# High Performance, Low Power, ISM Band FSK/GFSK/OOK/MSK/GMSK Transceiver IC

Silicon Anomaly

**ADF7023-J**

This anomaly sheet describes the known bugs, anomalies, and workarounds for the [ADF7023-J](#) transceiver and relates to Silicon Revision 2.2, which has corresponding silicon revision readback codes of 0x70, 0x23, 0x02, and 0x02. See the [ADF7023-J](#) data sheet for details on how to read the silicon revision codes.

Figure 1. Recommended Crystal Oscillator Configuration

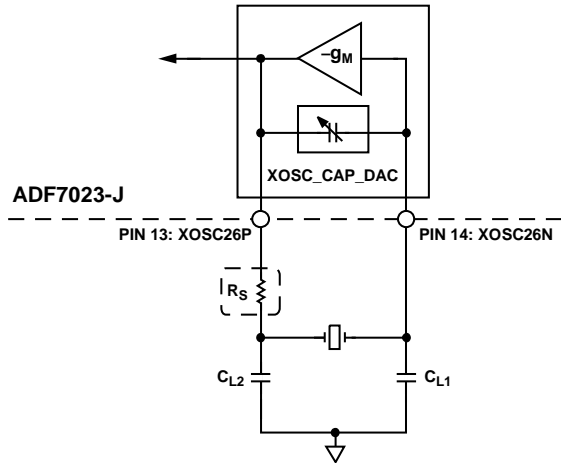
<b>Background Issue</b>	Under certain conditions, low frequency spurs can be induced in the crystal oscillator of the <a href="#">ADF7023-J</a> . The crystal oscillator circuit of the <a href="#">ADF7023-J</a> can exhibit spurs under certain conditions. These spurs are evident at RF at an offset frequency of approximately 7 kHz to 8 kHz. The spurs are more likely to occur with <ul style="list-style-type: none"> <li>• Reduced C<sub>LOAD</sub></li> <li>• Reduced Temperature</li> <li>• Increased XOSC_CAP_DAC value</li> </ul>
<b>Workaround</b>	These spurs do not occur in the condition where the crystal input XOSC26N is driven by an external source. See the <a href="#">ADF7023-J</a> data sheet for details on configuring for crystal oscillator operation. Introducing a series 150 $\Omega$ resistor on Pin 13 XOSC26P (R <sub>5</sub> in Figure 1), together with limiting the XOSC_CAP_DAC setting to a maximum value of 4, will eliminate these spurs over the temperature range of the device.
